10 CFR 50.54(q)(5) Procedure Change Summary Analysis

Exelon Generation Company, LLC (Exelon) is submitting the following Emergency Plan Annex revisions for Limerick Generating Station (LGS), Peach Bottom Atomic Power Station (PBAPS), and R. E. Ginna Nuclear Power Plant (Ginna):

**EP-AA-1007, Revision 33, "*Exelon Nuclear Radiological Emergency Plan
Annex for Peach Bottom Atomic Power Station*"**

Figure PBAPS 4-1: Off – Site Assembly Location

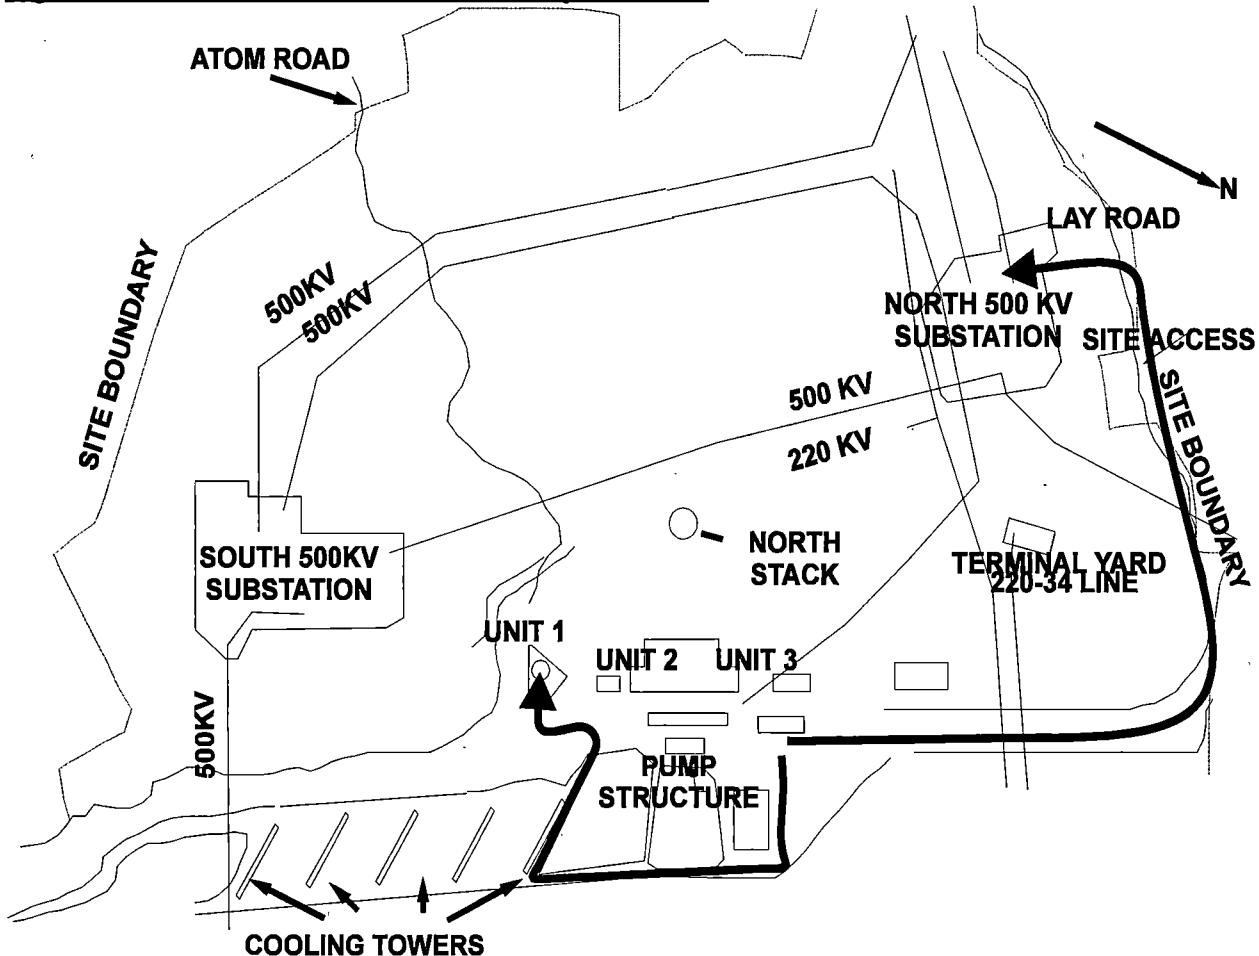
- In Table PBAPS 5-1, *"Emergency Supplies and Equipment,"* the name of Location 13, *"Health Physics,"* was revised to read Location 13, *"Radiation Protection Muster Area."*
- In Appendix 2, the name for *Harford Memorial Hospital* was changed to *University of Maryland Harford Memorial Hospital*.
- The older Seismic Monitoring System (SMS) has been replaced by a newer design. The new SMS was installed under a site-approved design change modification that meets applicable regulatory requirements, guidance, and standards related to seismic monitoring. The SMS consists of accelerometers located throughout the plant, a free-field sensor located on the site property away from buildings, and
